February 28, 2017
BOARD OF COUNTY COMMISSIONERS
ORANGE COUNTY, FLORIDA
Y17-731-CC / ADDENDUM # 3
WITTENSTEIN COTTAGE ADA UPGRADES AND RENOVATIONS
Bid Opening Date: March 7, 2017

This addendum is hereby incorporated into the bid documents of the project referenced above. The following items are clarifications, corrections, additions, deletions and/or revisions to and shall take precedence over the original documents. Underlining indicates additions, deletions are indicated by ~~strike through~~.

STAIRCASE DETAILS

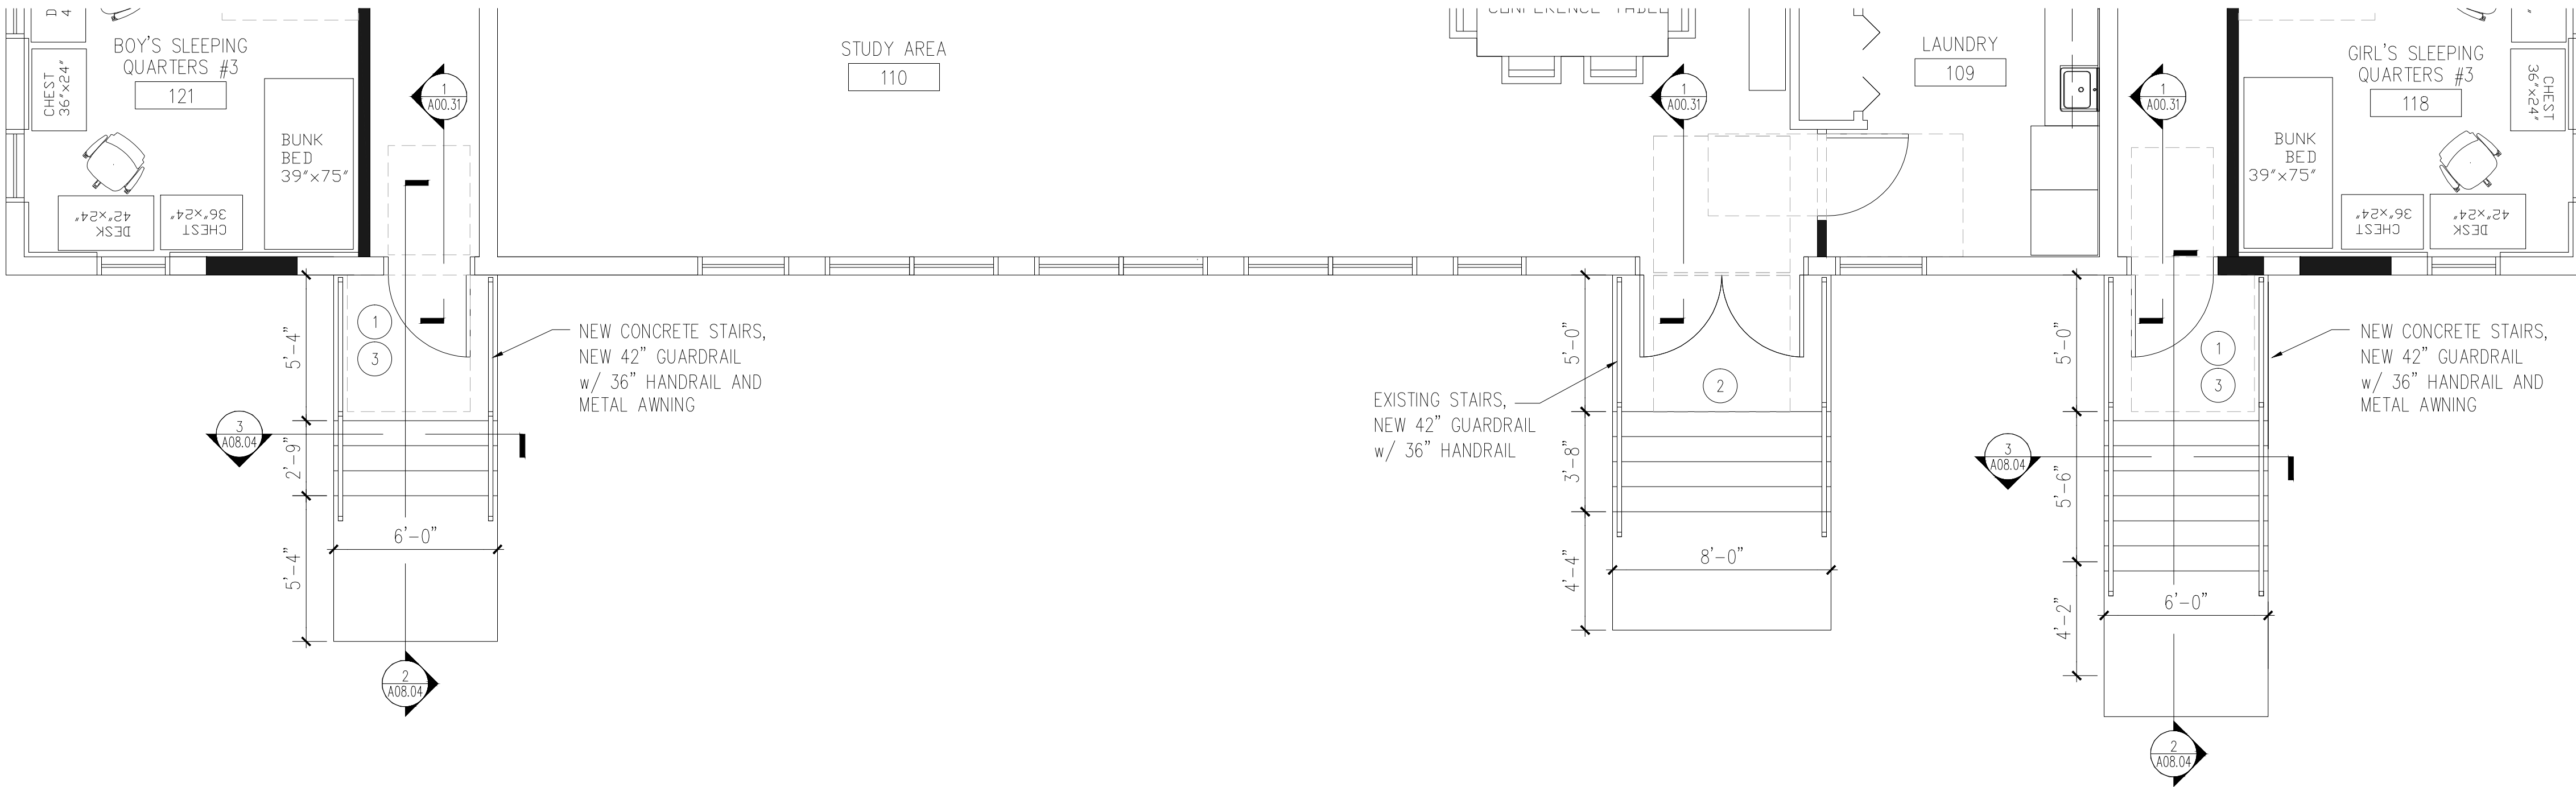
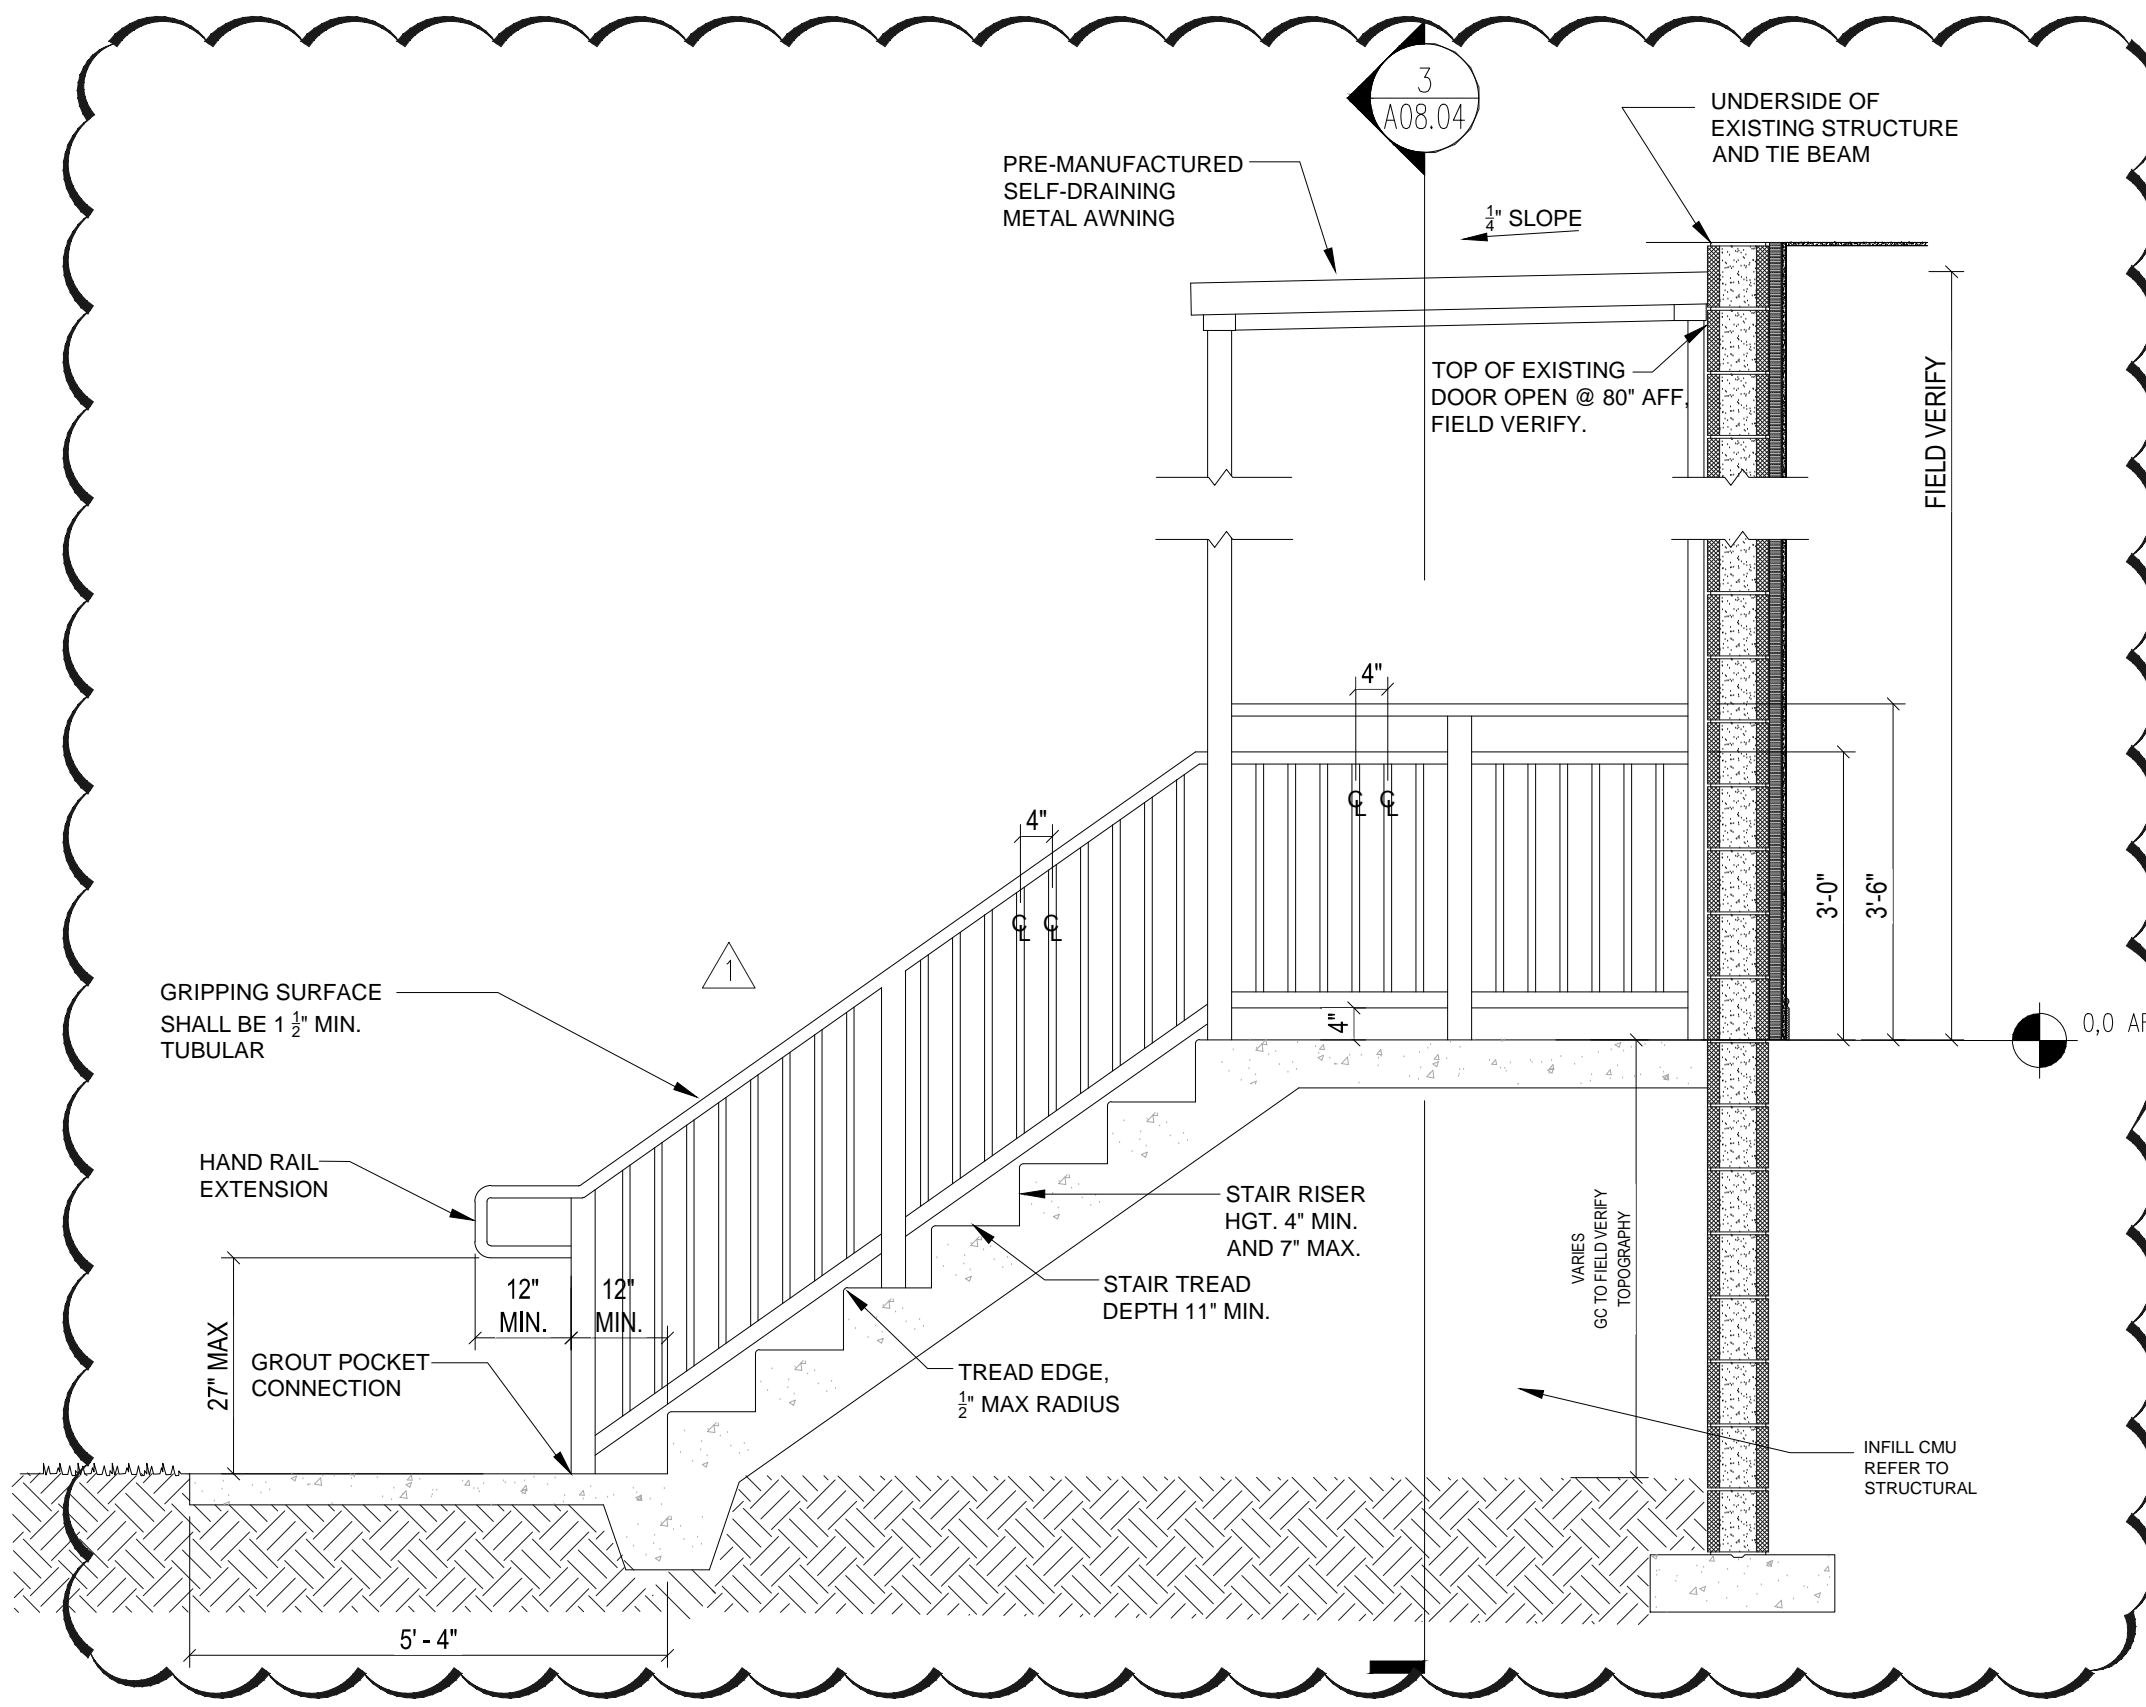
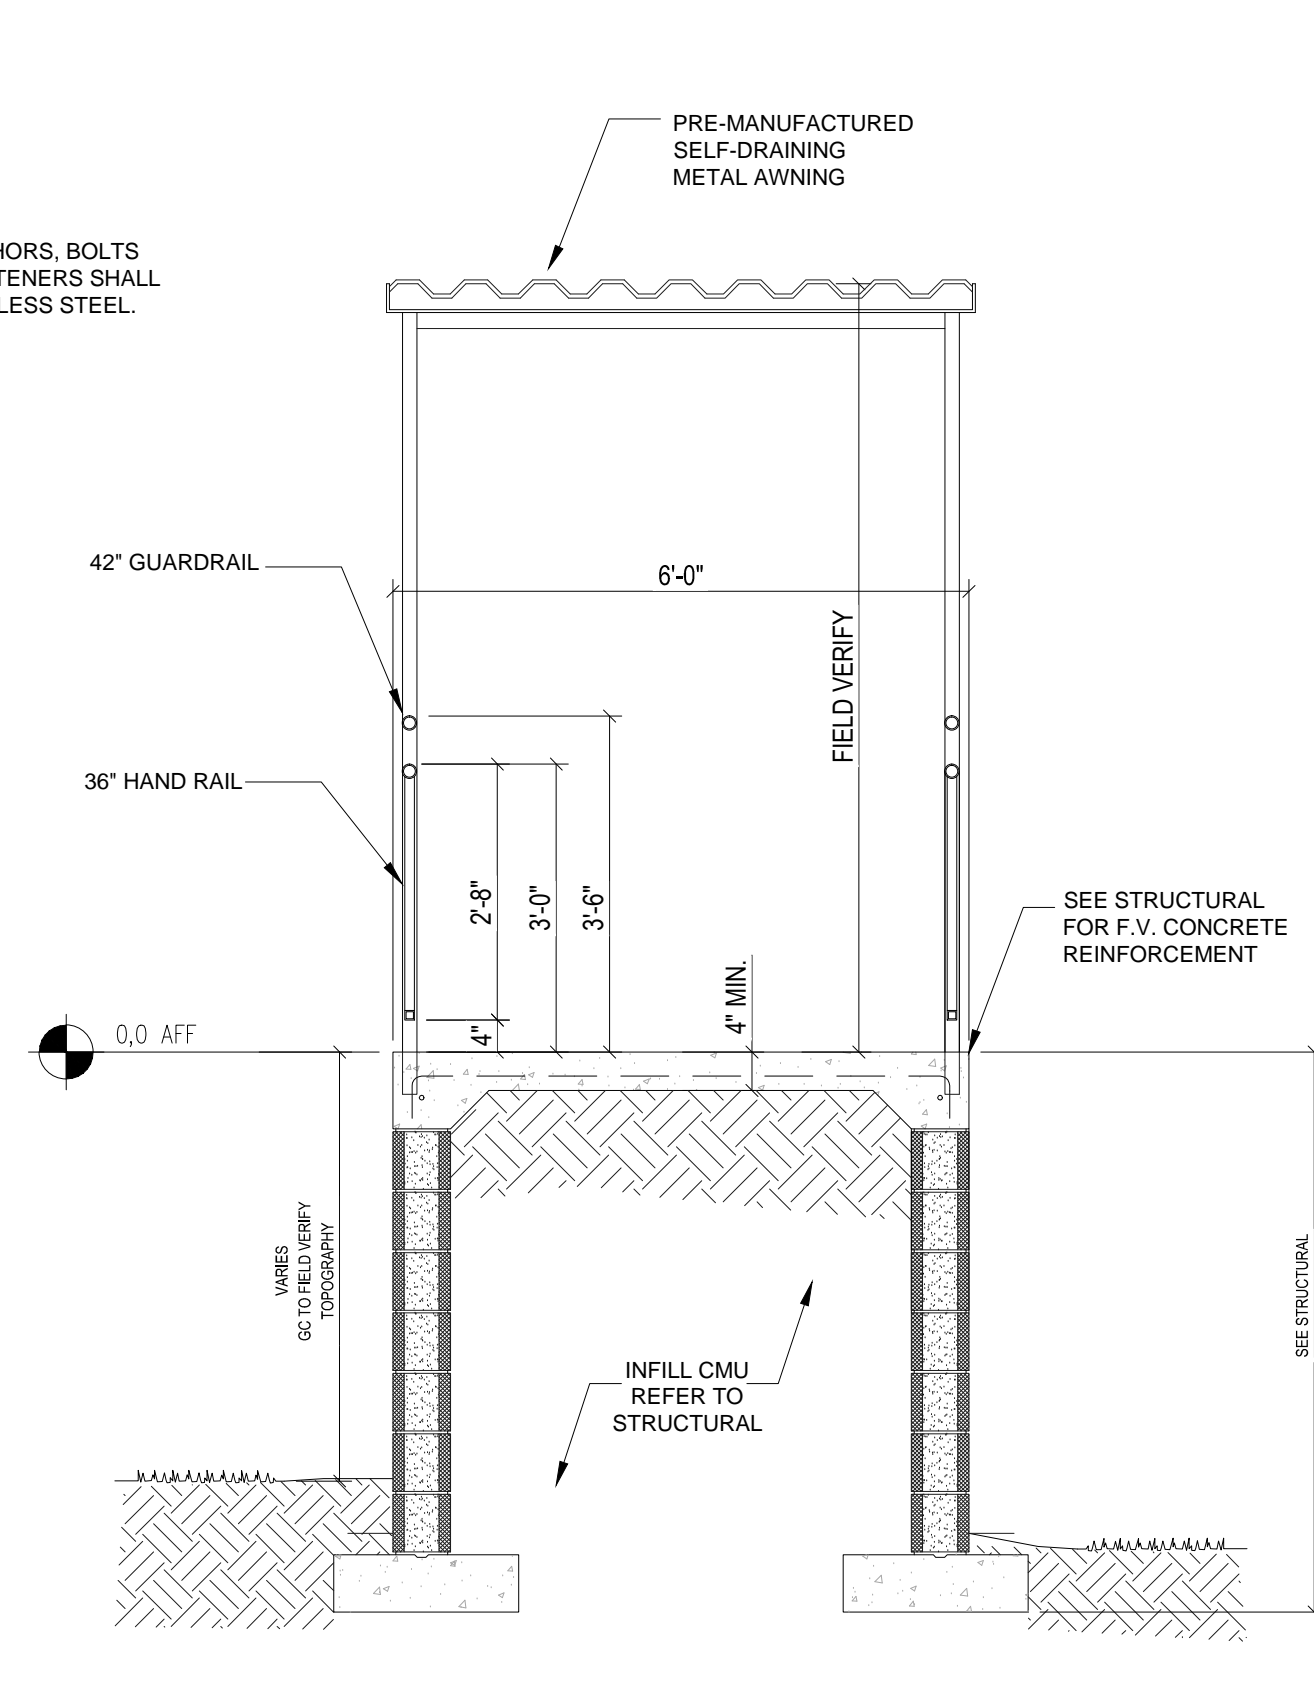
12. Question: Regarding the handrail details on A08.04, can FRP handrail be bolt-down in lieu of pocketed?

14. Question: The drawings call for tubular steel handrails on page A08.04 but the specifications contain only sections for Aluminum and FRP handrails. Which of these three options will be used?

Answer: No.

Answer: Aluminum or FRP handrails will be accepted, per specification manual.
